Cleveland City Planning Commission

March 20, 2026

Agenda: March 20, 2026

Streetscapes-260006 – E72nd Street Pole Banner Installation

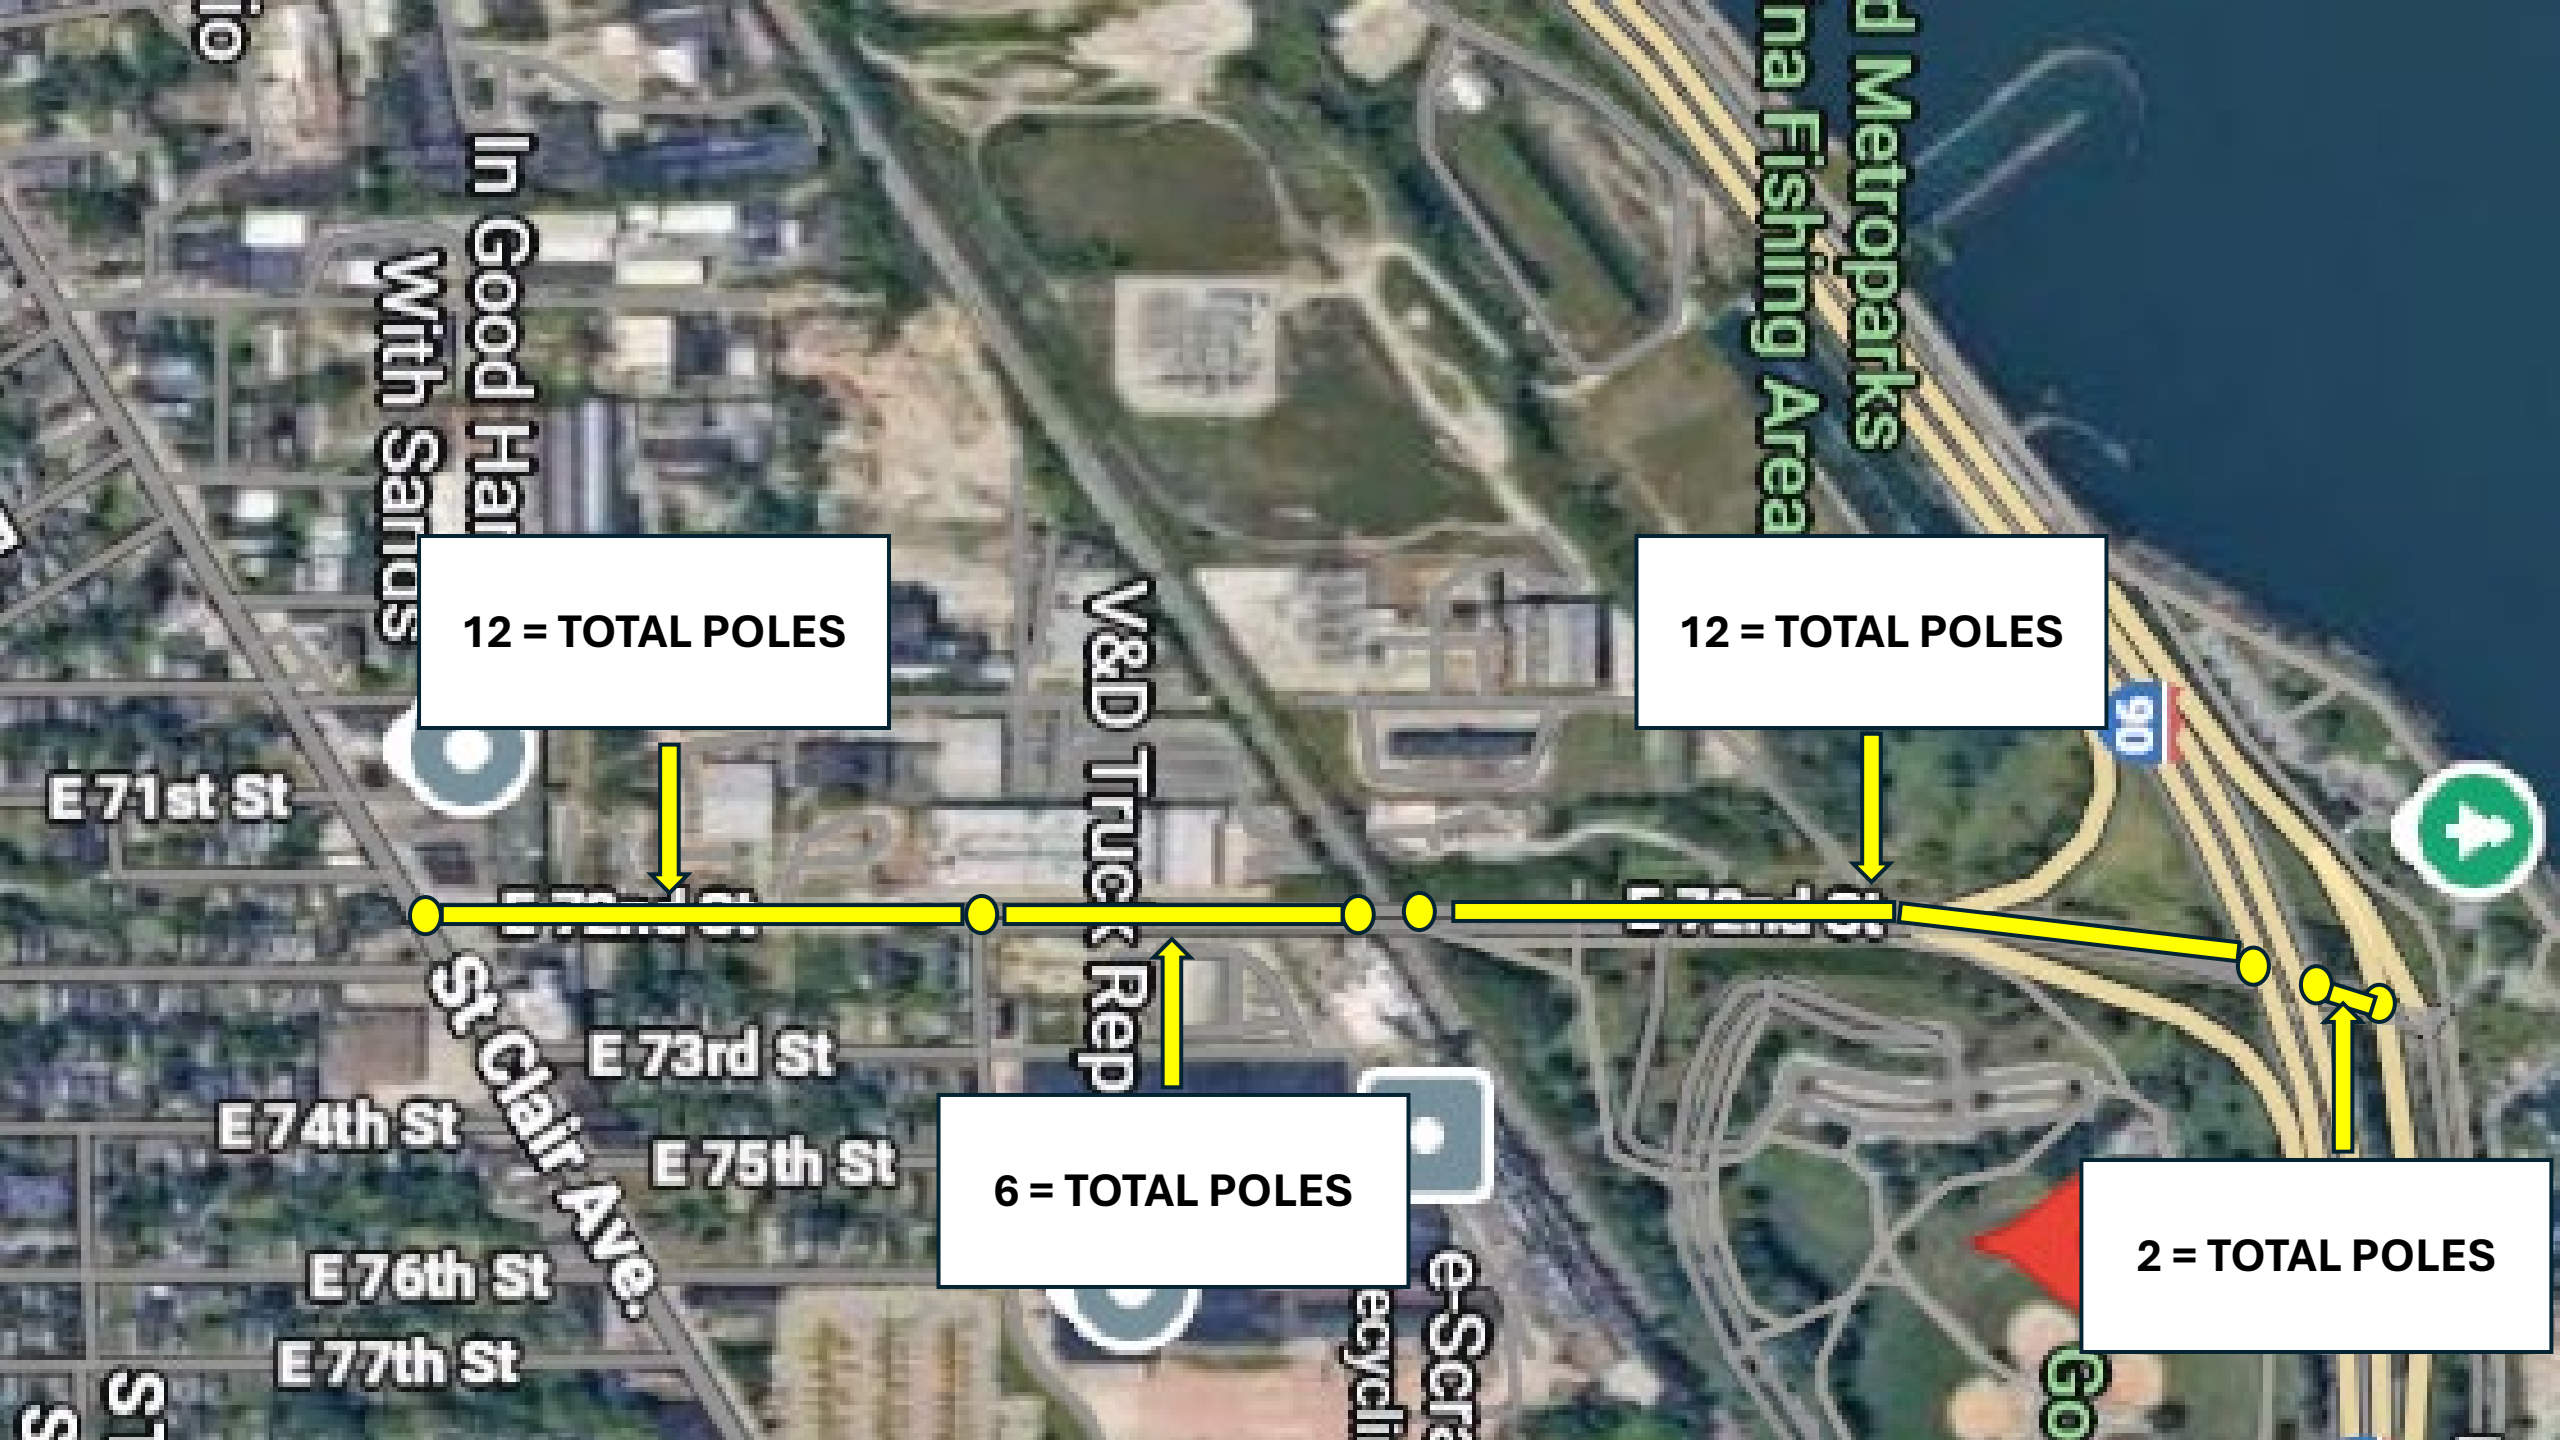
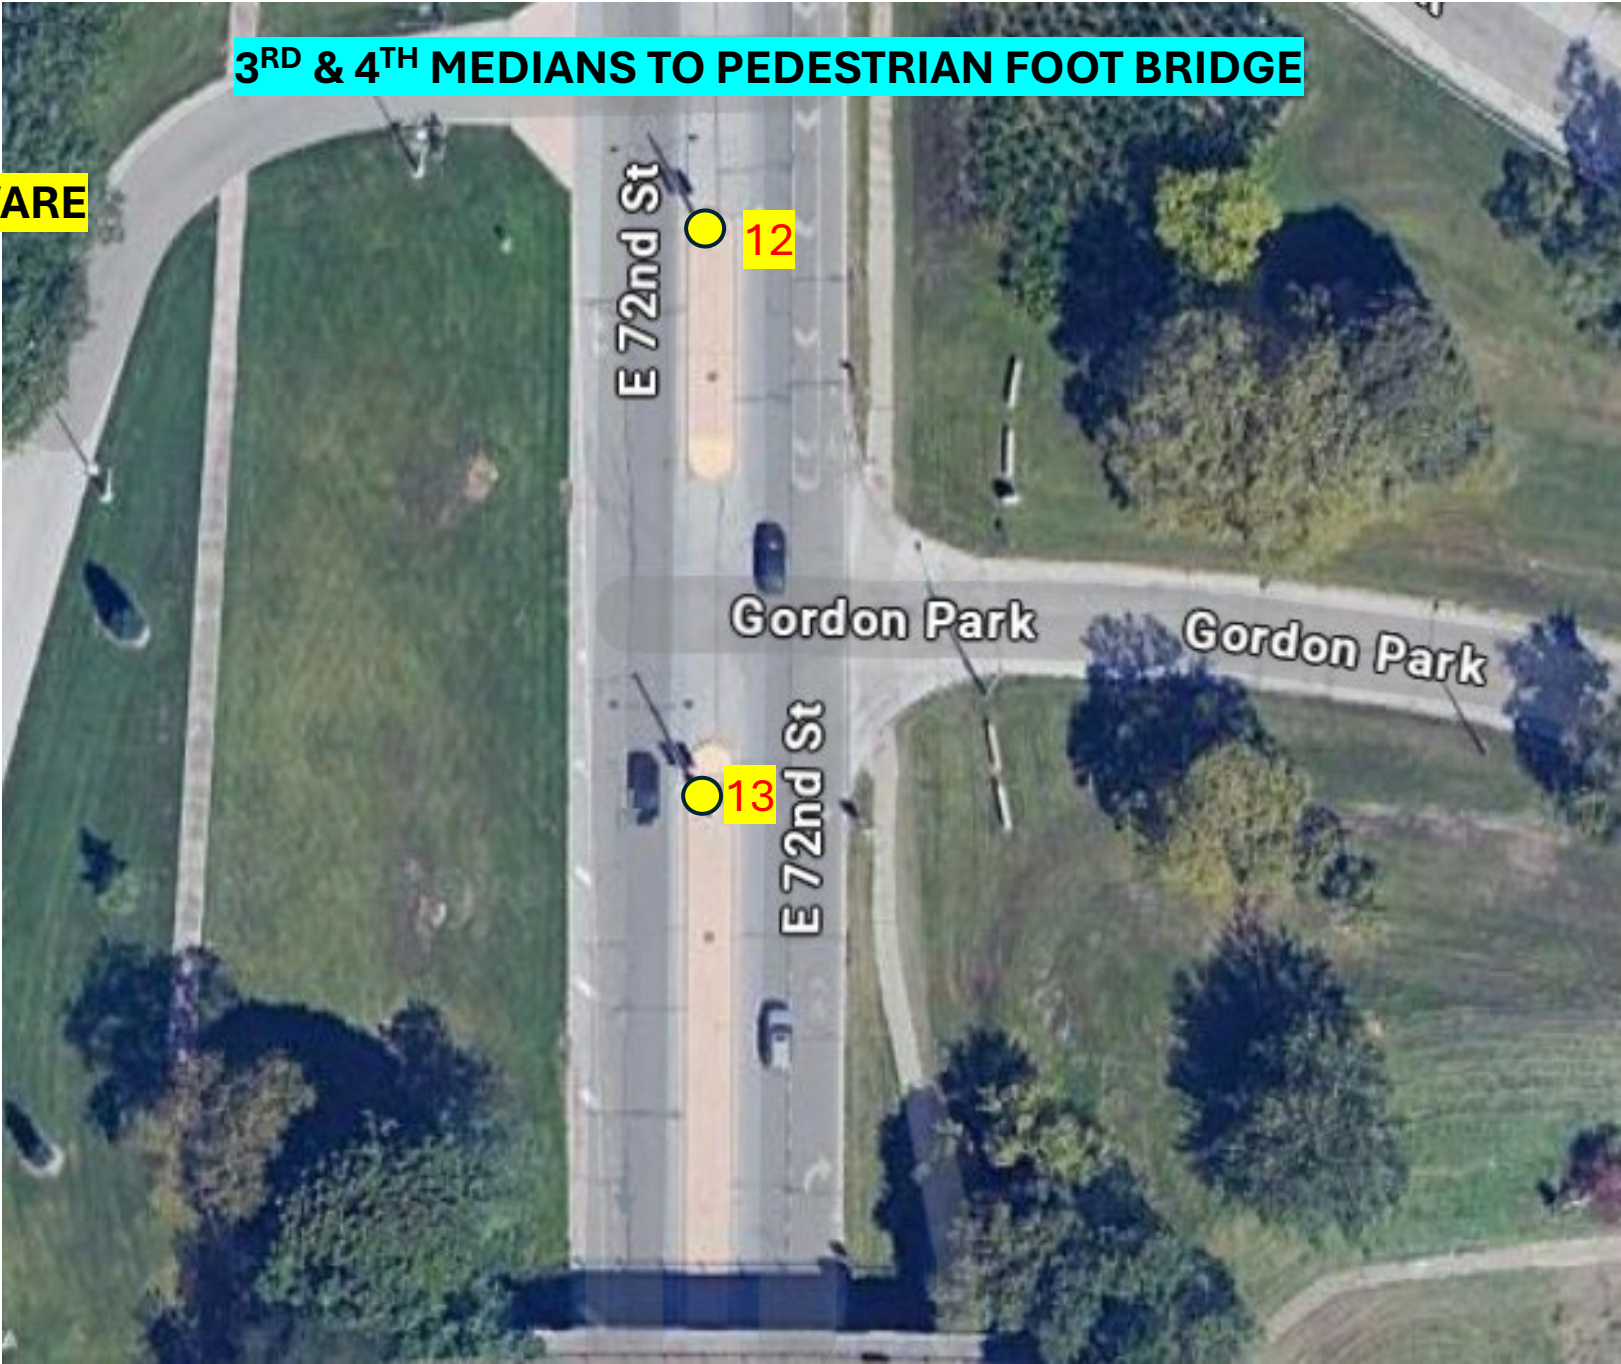
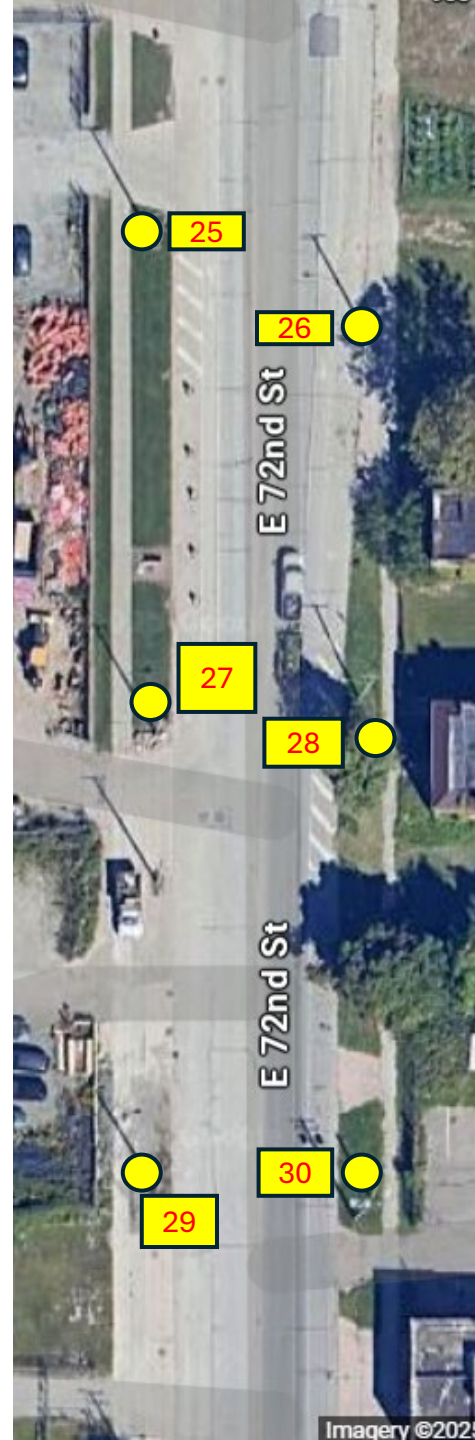
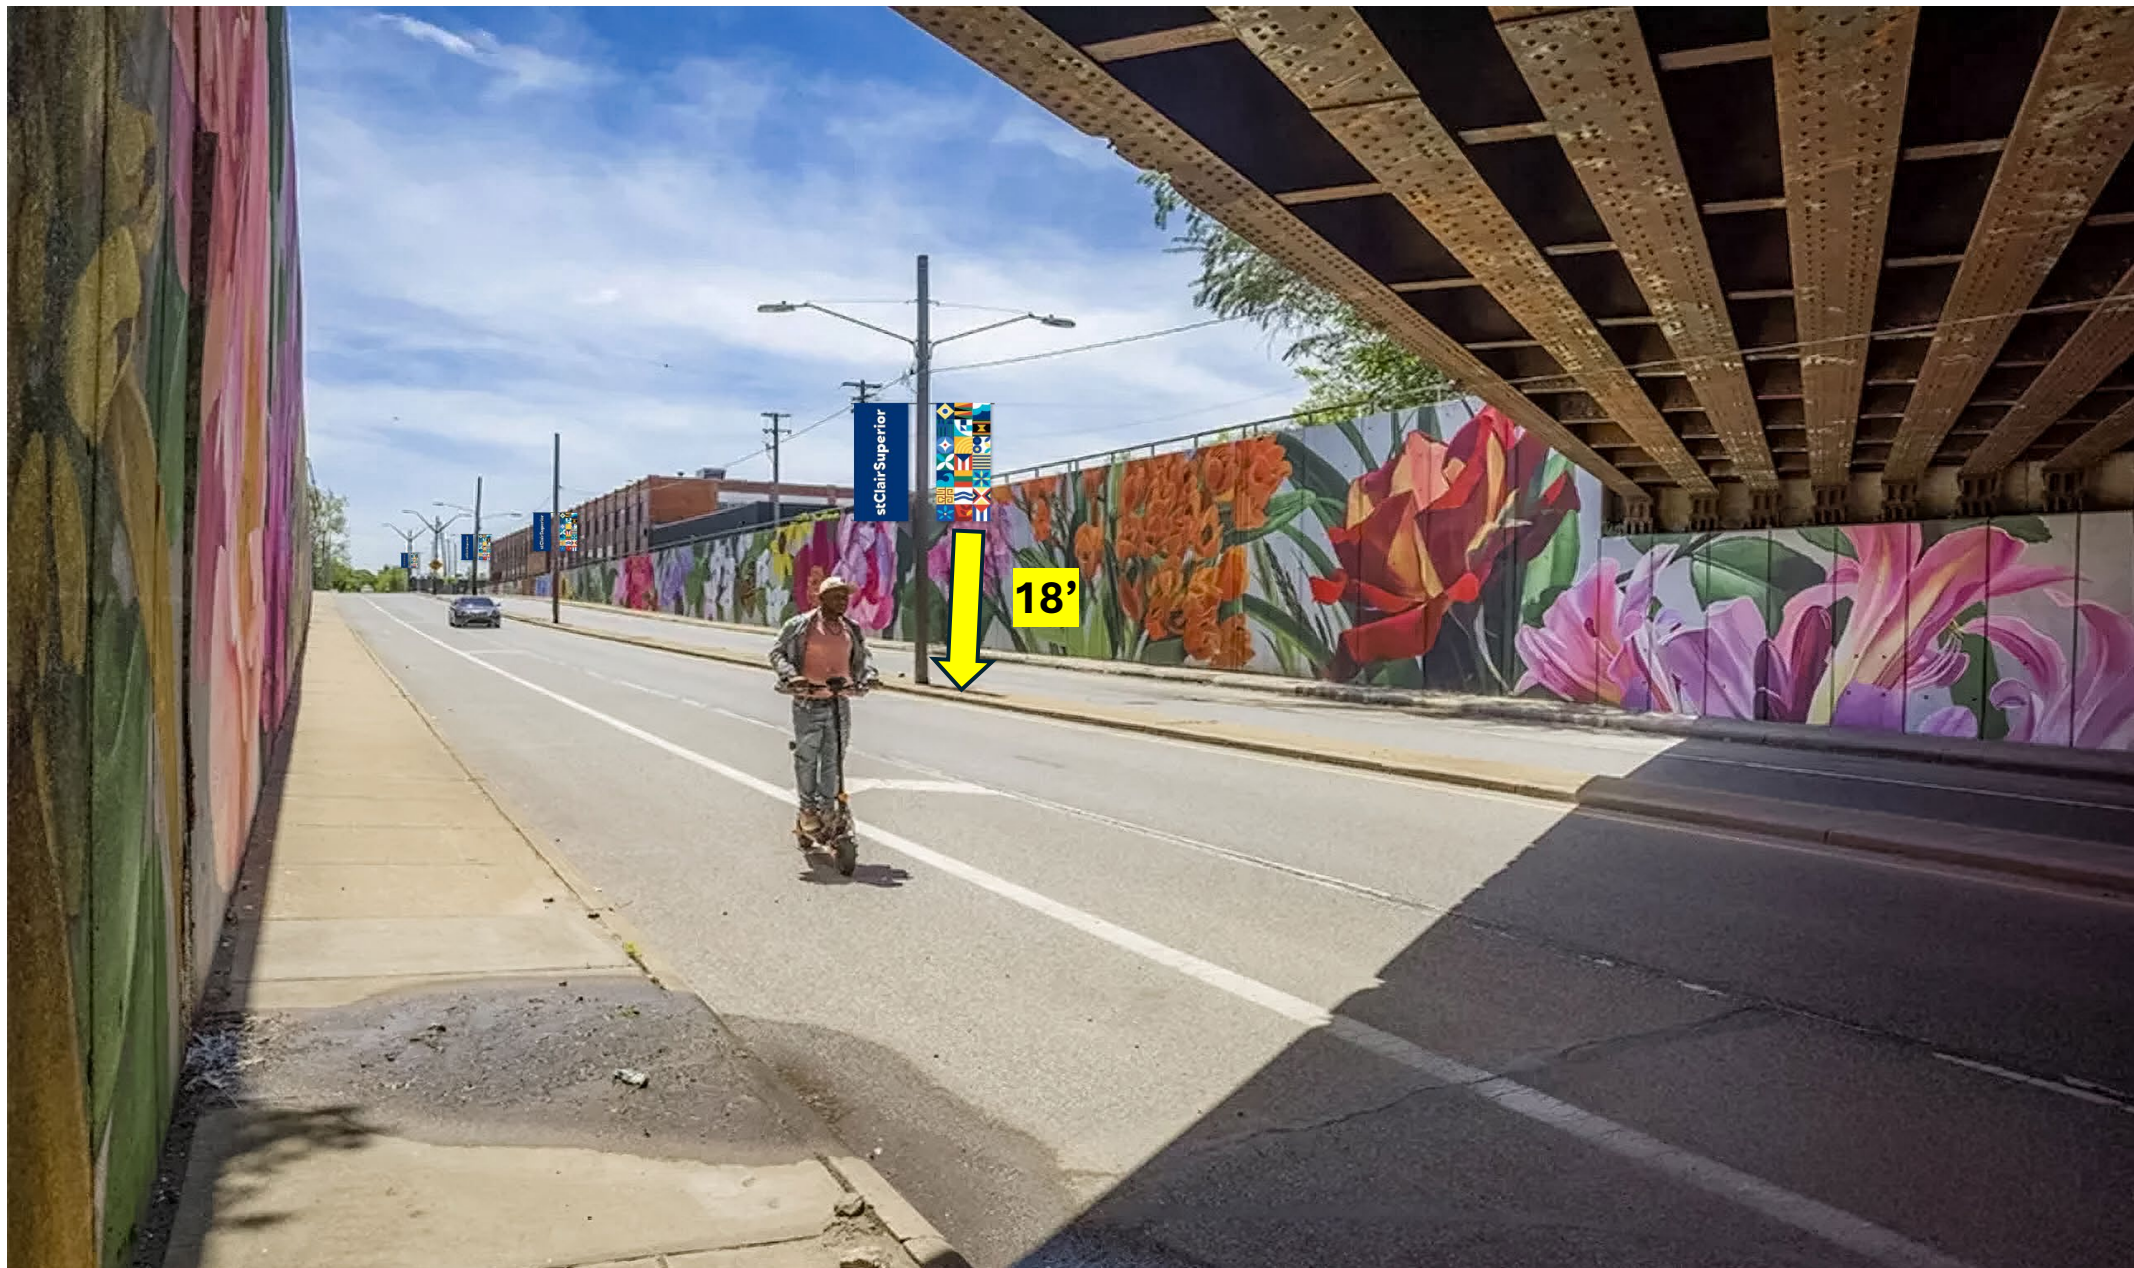
NEDRAC recommended final approval on 3/17/26 with the condition to take consideration of the orientation of the letters and graphics.

CONCEPTUAL PLAN – 2ND FLOOR

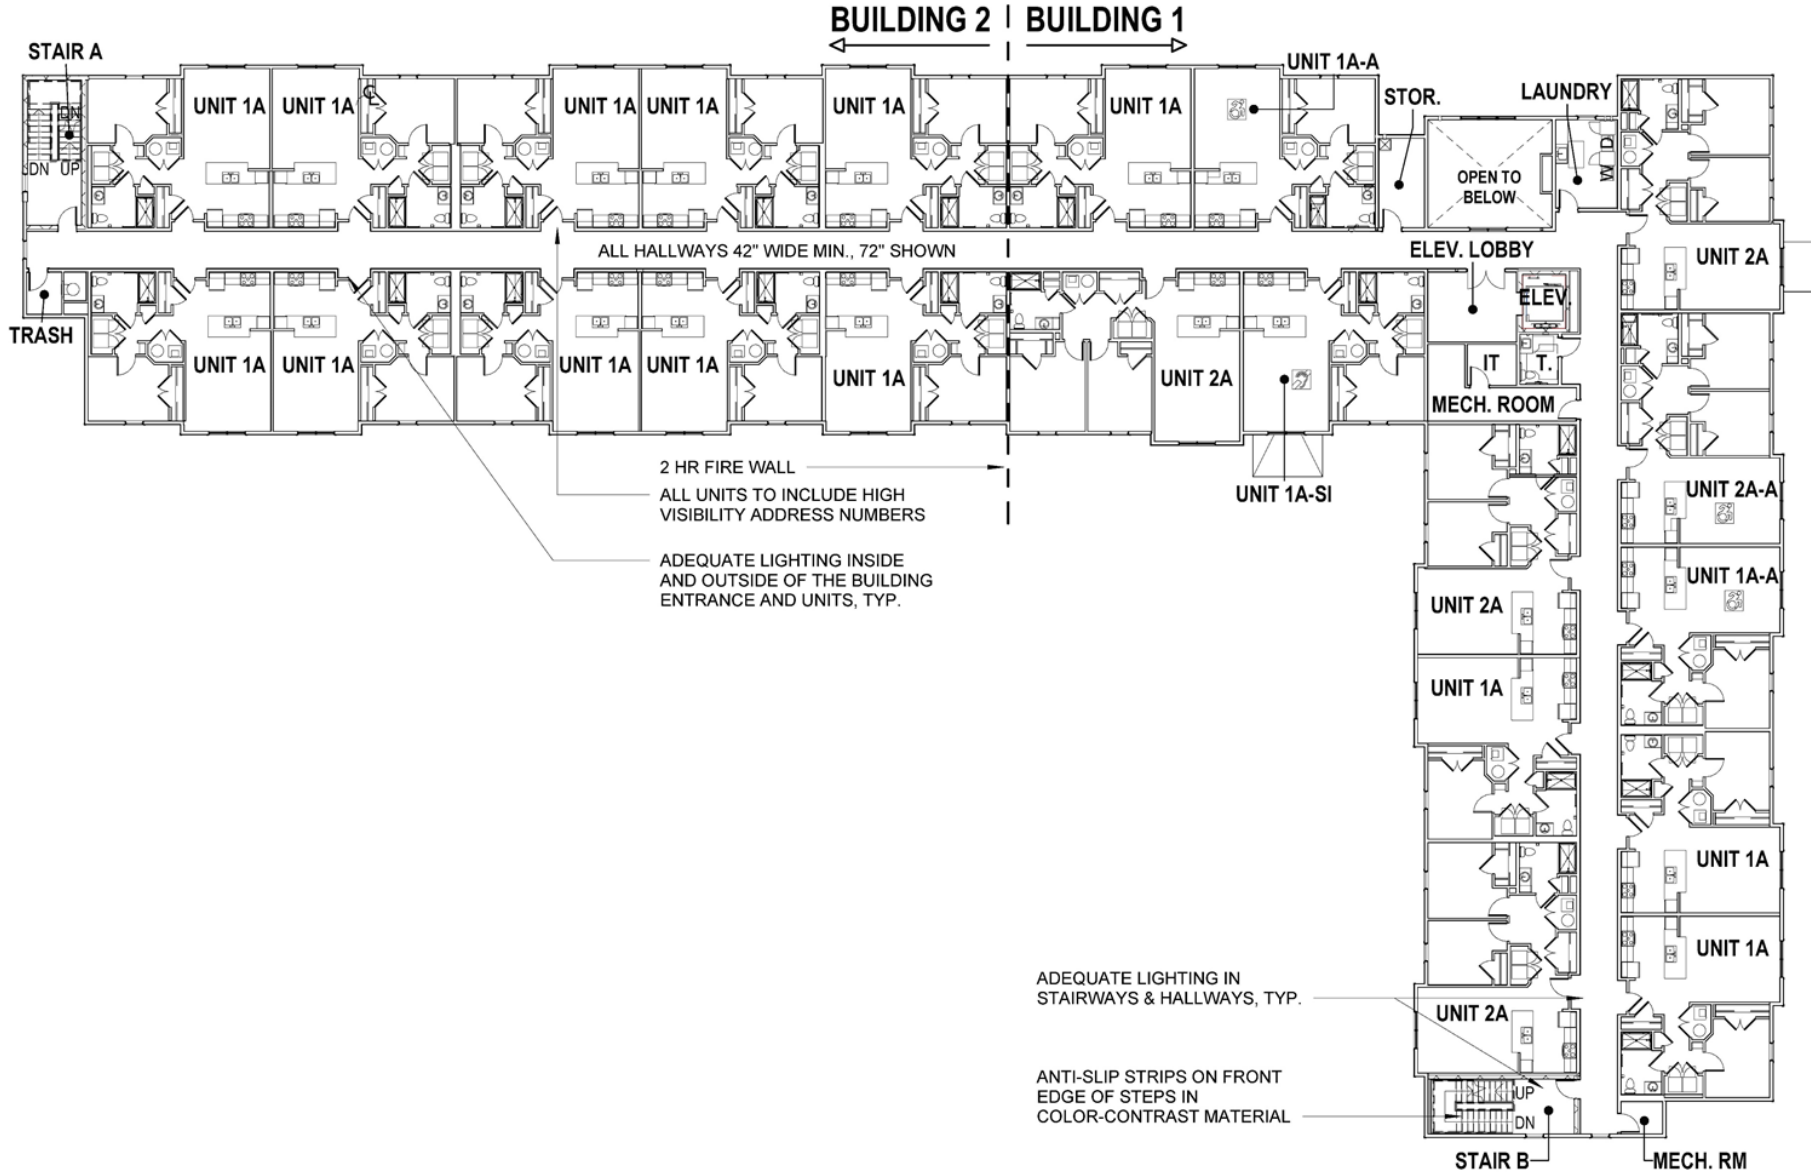
- REWORKED COMMON/ OFFICE SPACES
- ENTRANCE LOBBY/ CIRCULATION
- FLIP UNIT
- BUILDING PERIMETER

ADEQUATE LIGHTING IN
STAIRWAYS & HALLWAYS, TYP.

ANTI-SLIP STRIPS ON FRONT
EDGE OF STEPS IN
COLOR-CONTRAST MATERIAL
